SUBJECT: Bulletin "C" Dated May 7, 2020
PROJECT #: A1310-00
DESCRIPTION: Restoration Upgrades to Exterior Building Envelope
State Office Building - 135 Hanover Street
Trenton, Mercer County, NJ

PROJECT#: A1310-00 Restoration Upgrades to Exterior Building Envelope
State Office Building
135 West Hanover Street,
Trenton, Mercer County, N.J.

BULLETIN “C”

Sheet No.
A100
Sheet 4 of 20
©Lamme + Giorgio 2019

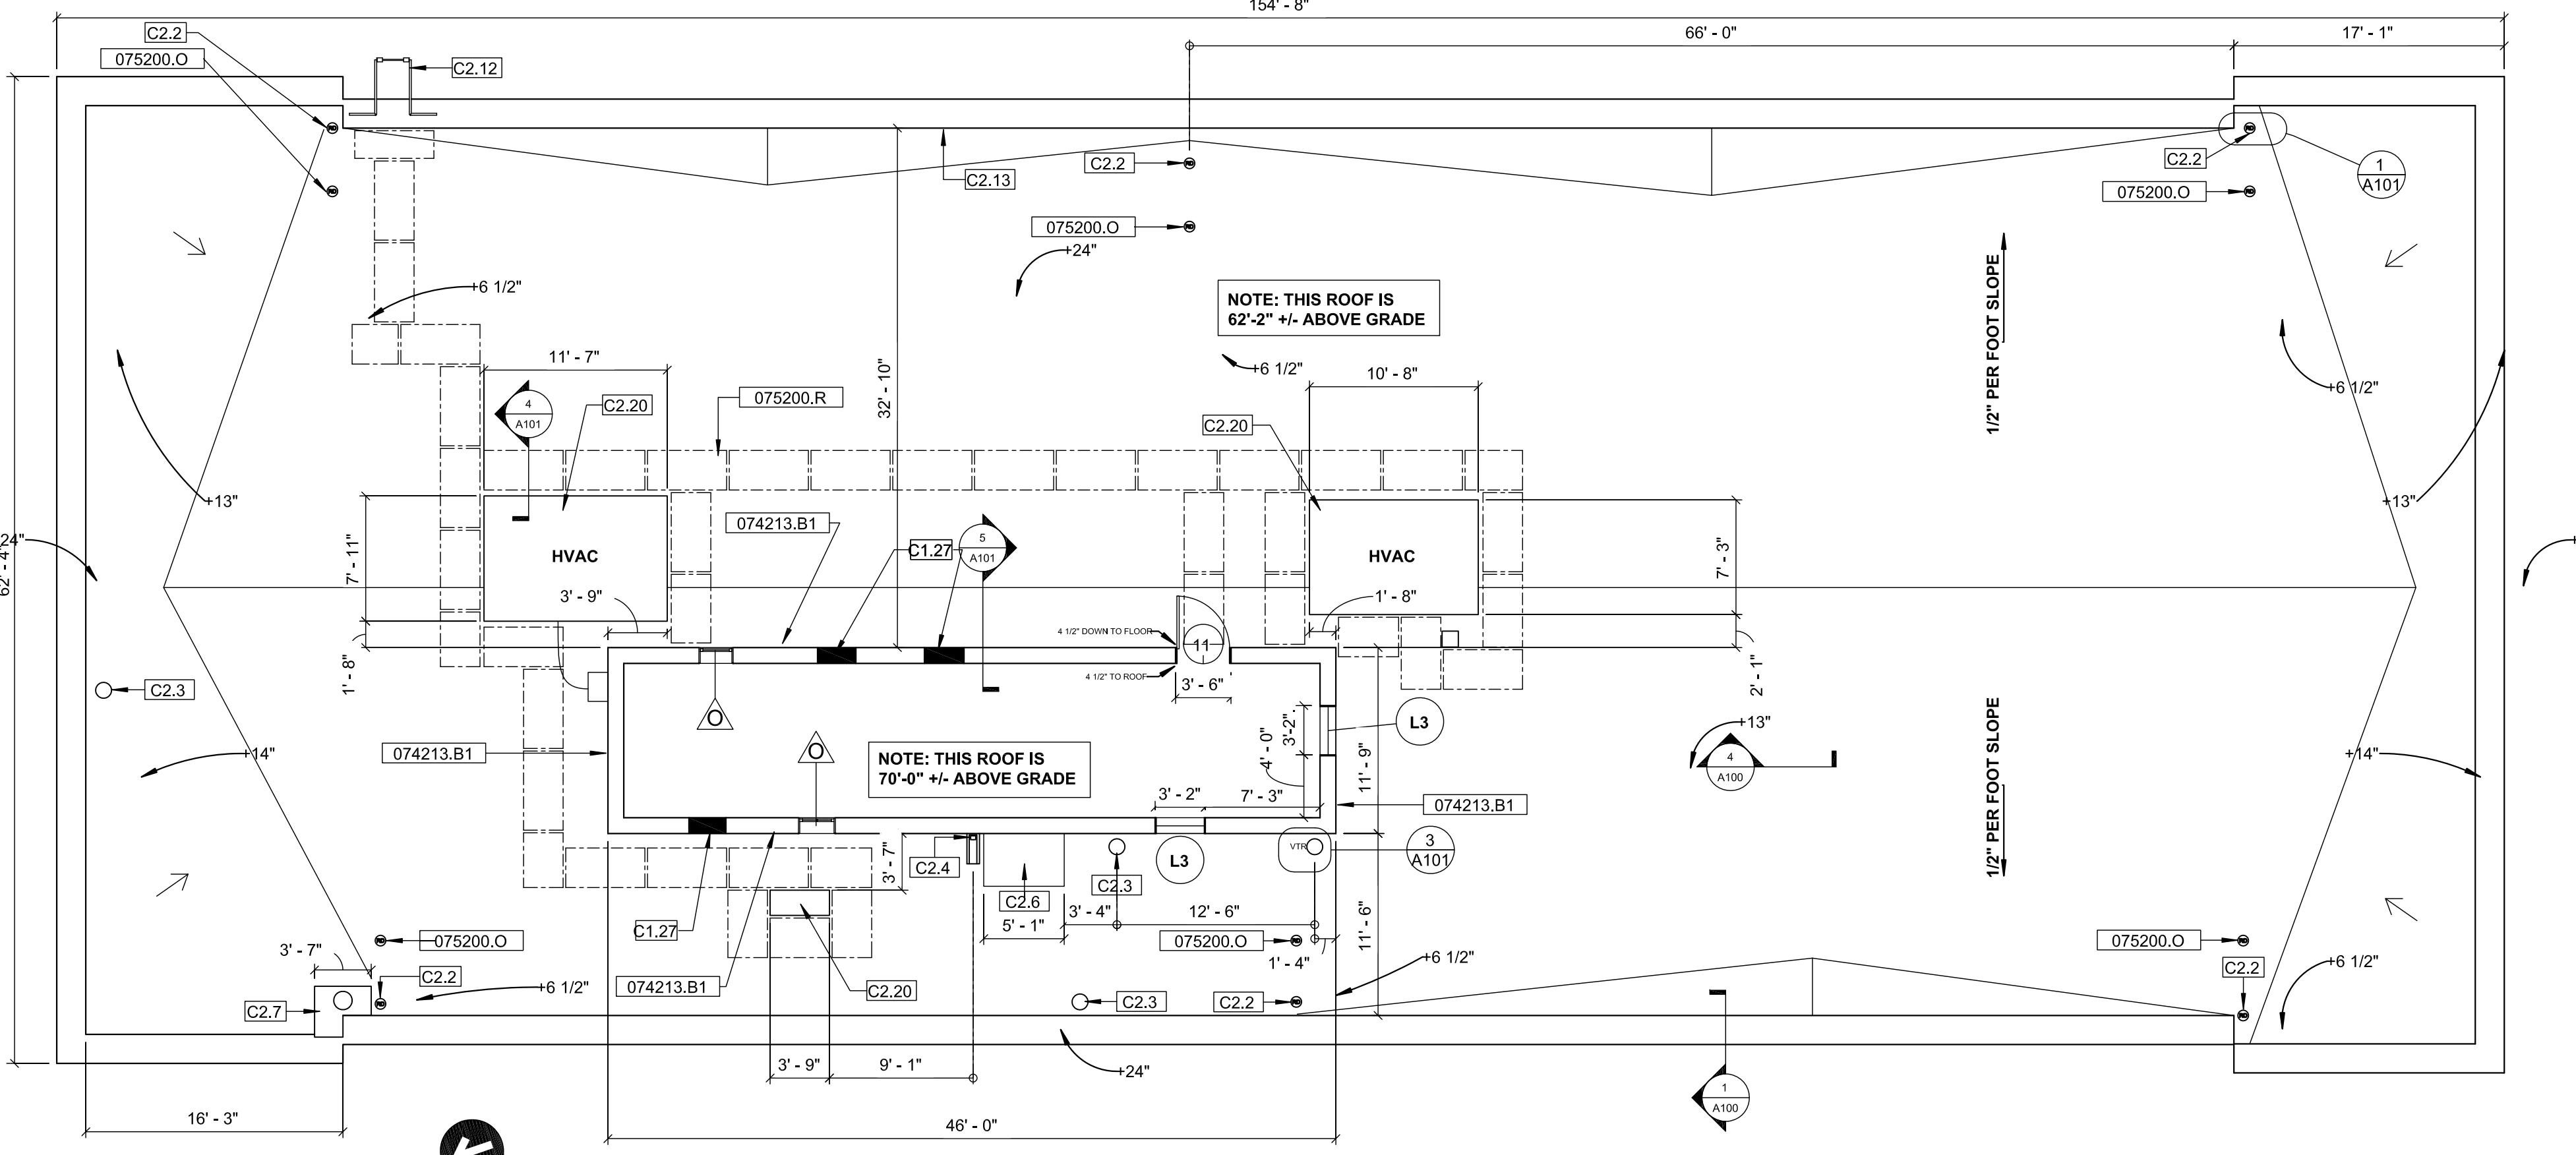
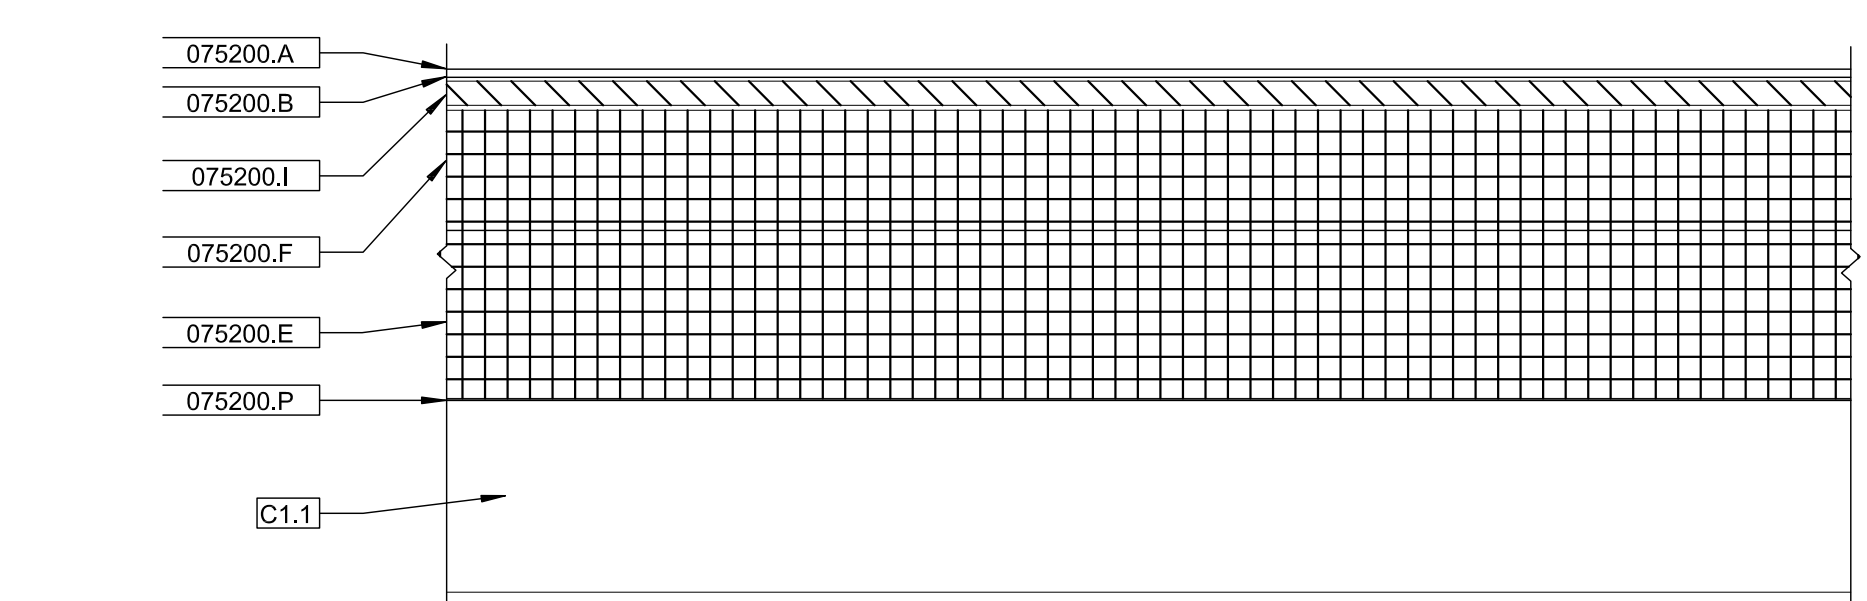
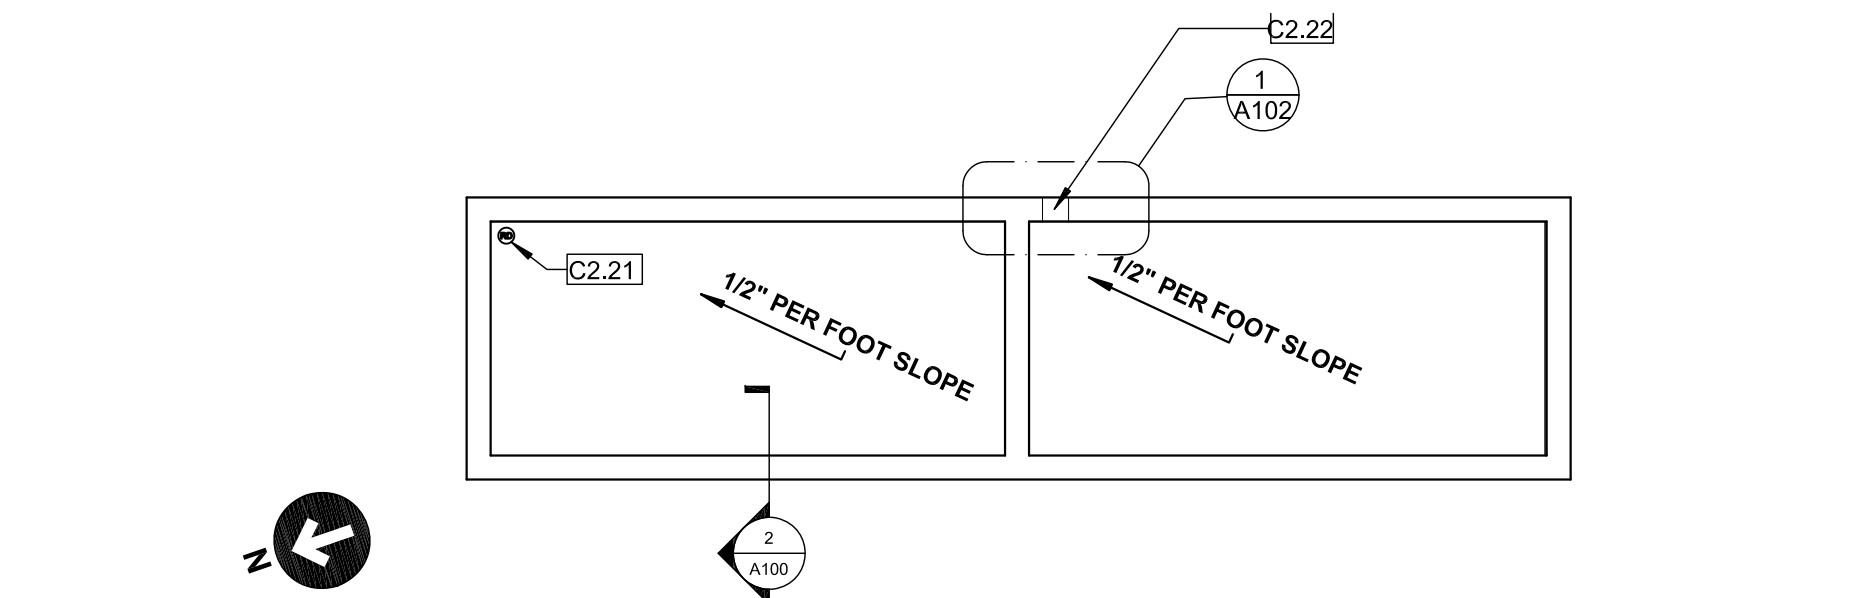
1. Delete all reference to removal of existing coping.
2. Drawing Sheet D100, delete in its entirety and replace with attached “Revised Drawing D100”.
3. Drawing Sheet A100, delete in its entirety and replace with attached “Revised Drawing A100”. Refer to Detail 1/A100.
4. Drawing Sheet A103, delete in its entirety and replace with attached “Revised Drawings sheet A103”. Refer to revisions to Window Types.
5. Drawing Sheet A200, delete in its entirety and replace with attached “Revised Drawings sheet A200”. Refer to revised Window Types.
6. Drawing Sheet A201, delete in its entirety and replace with attached “Revised Drawings sheet A201”. Refer to revised Window Types.
7. Delete all reference to Window Type ‘C’ from the drawings

7. Does the coping removal apply to all elevations? The structural drawings show the coping to be pointed/caulked.

RESPONSE: The coping will be pointed and caulked as shown on the structural drawings and then wrapped with new aluminum coping. See attached "Revised Drawing Sheet D100" and "Revised Drawing A100".
